Access Compliance Report

Public Rights-of-Way

(Curb Ramps)

Intersection ID: 50321	Main Street: BELMAR_PLACE_RD	Cross Street: CINDY_LN	Location: SE
ADA ID: 60272EC37590	Ramp Type: Directional1	Initial Pass/Fail: Pass	Overall Compliance: No
Codes/Mitigation Info/Possible Solution		Field Measurements/Component Compliance	
Severity Score: 10

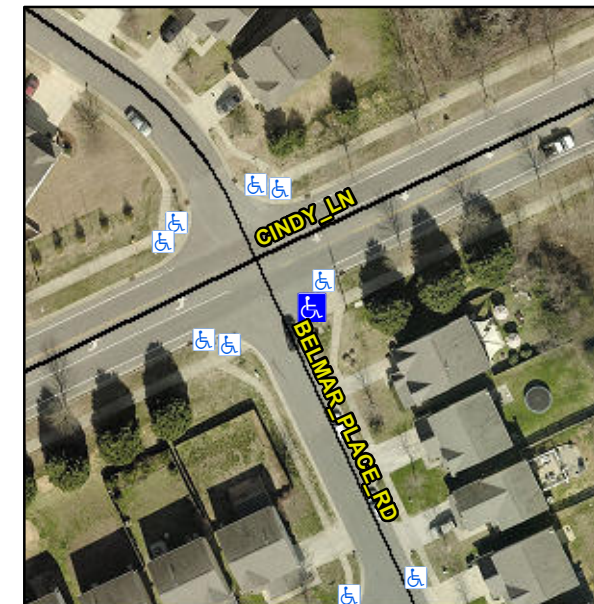
**Not Found, R305.1.4, R305.2,
R302.7.2, R304.5.3**

Compliance	Description	Data	Compliance	Description	Data
N/A	Ramp Length (in)	116.5	Yes	Grade Break?	Yes
Yes	Ramp Width (in)	68.0	Yes	Grade Break Slope (%)	4.6
Yes	Ramp Slope (%)	5.5	Yes	Grade Break XSlope (%)	0.4
Yes	Ramp XSlope (%)	1.1			
Yes	Flare Type LT	N/A	Yes	Flare Type RT	N/A
N/A	Flare Slope LT (%)	N/A	N/A	Flare Slope RT (%)	N/A
N/A	Flare Traversable LT?	No	N/A	Flare Traversable RT?	No
Yes	Landing Length (in)	76.5	Yes	DWS Provided?	Yes
Yes	Landing Width (in)	71.5	Yes	DWS Contrast?	Yes
Yes	Landing Slope (%)	1.9	Yes	DWS Length (in)	24.0
Yes	Landing X Slope (%)	0.9	No	DWS Full Width?	No
N/A	Landing Curb? (Y/N)	N/A	No	DWS Offset LT (in)	8.5
N/A	Shared Landing?	Yes	Yes	DWS Offset RT (in)	40.5
Yes	Gutter Ponding?	No	Yes	Gutter Slope (%)	0.6
No	Gutter Lip Ht (in)	0.3	No	Gutter X Slope (%)	2.7
N/A	Painted X Walk1?	No		Road Slope (%)	2.0
	X Walk 1 Direction	To W		Road X Slope (%)	3.6
	X Walk 1 Width (in)	N/A		Clear Space?	Yes

X Walk 1 Slope (%)	2.0	N/A	Clear Space to XWalk (in)	N/A
	X Walk 1 X Slope (%)	3.6	Yes	Storm Grate/Utility Hazard?	No
N/A	Ramp inside XWalk1?	N/A		Storm Grate/Utility Type	
Yes	Any Obstructions?	No			N/A
	Obstruction Type		Yes	Surface Condition? (G/P)	Good
			N/A	Curb Slope (%)	11.0

**Remove & Replace Entire Ramp.
Remove & Replace Gutter.**
